From: Rael, Rudy E.
Sent: Thursday, January 19, 2017 9:24 AM
To: 'David Soule (david@riograndeengineering.com)'
Subject: 6401 Picardia

Based upon the information provided in your submittal received 1/17/17, the above referenced Grading and Drainage plan dated 1/16/17 cannot be approved for Grading Permit until the following comments are addressed:

ENGINEER'S SEAL  1/16/17 DAVID SOULE P.E. #14522	LOT 29, BLOCK 8, UNIT 22 VOLCANO CLIFFS	DRAWN BY JDG
	GRADING AND DRAINAGE PLAN	DATE 01-15-2017
 1606 CENTRAL AVENUE SE SUITE 201 ALBUQUERQUE, NM 87106 (505) 872-0999		SHEET # 1 OF 1
		JOB #

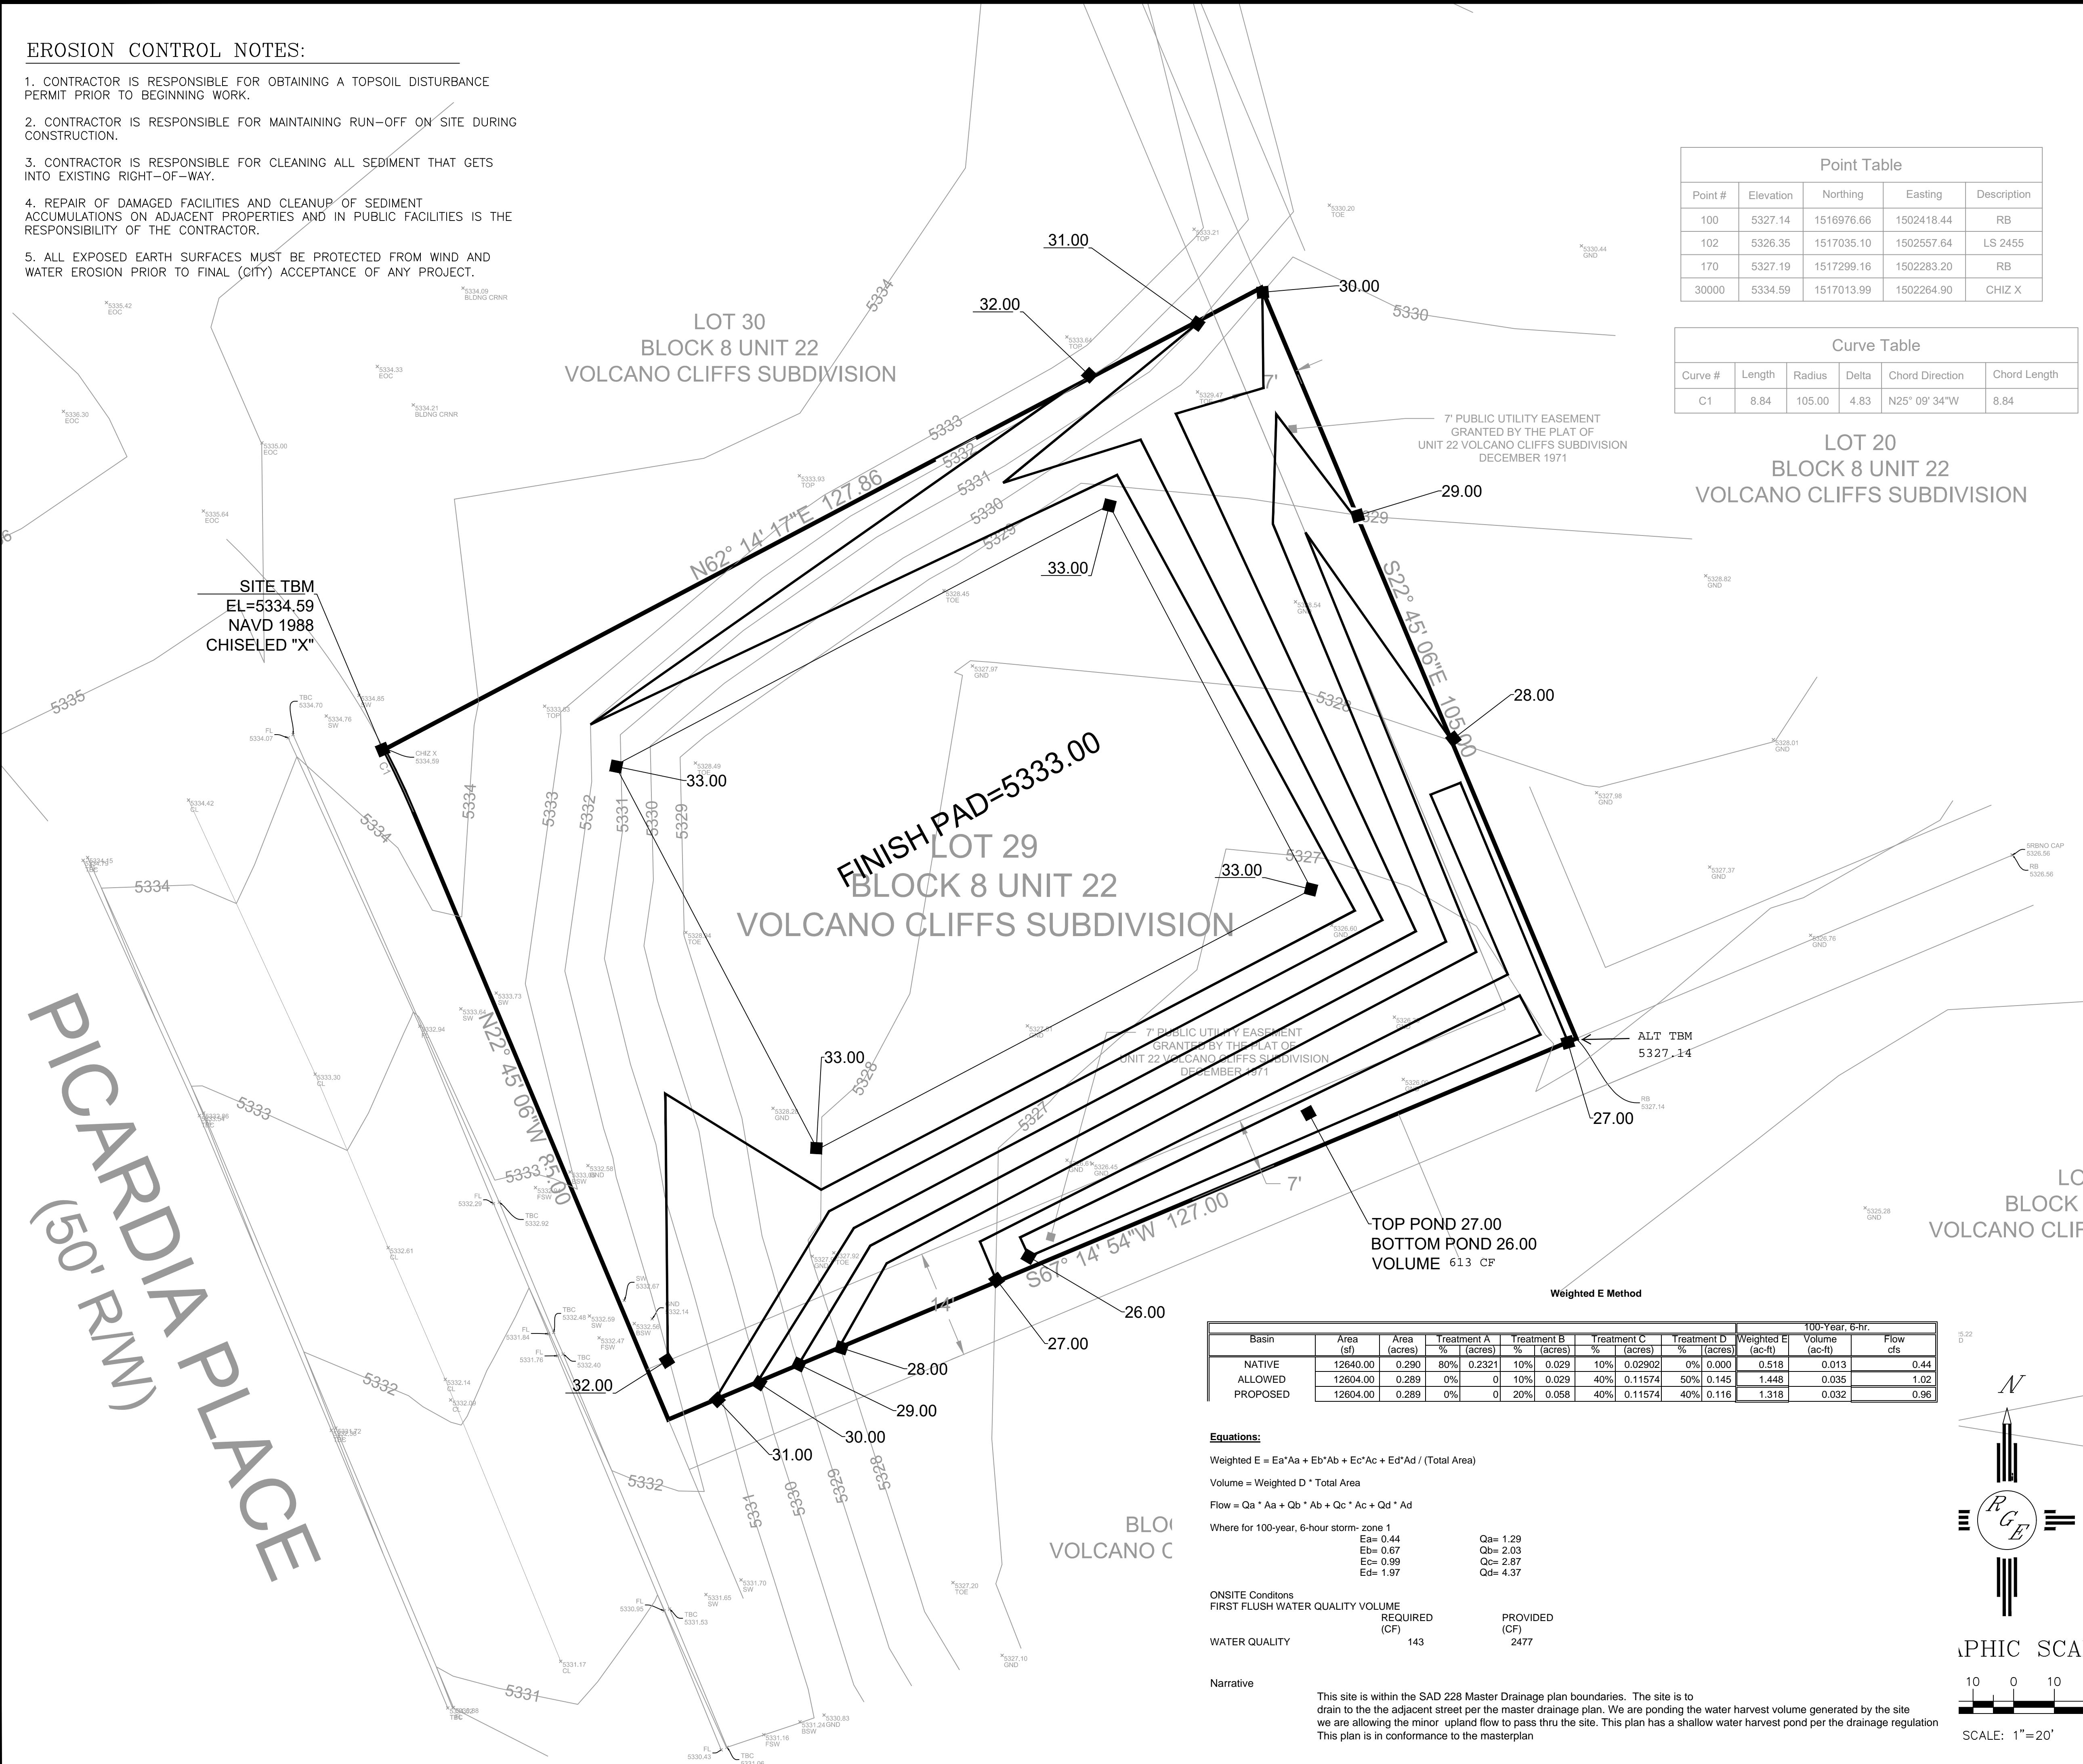
- Provide a note stating that future garden walls require a separate permit and this plan should be used for their placement.
- Also state that future garden walls require an opening 3" above grade in the NW corner and SW corner.
- Provide a note stating retaining walls are not allowed in the rear yard unless a swale is provided so flows may pass from the property to the north into their property and to the south property.
- Provide a statement that a pad certification is required before a building permit is given.
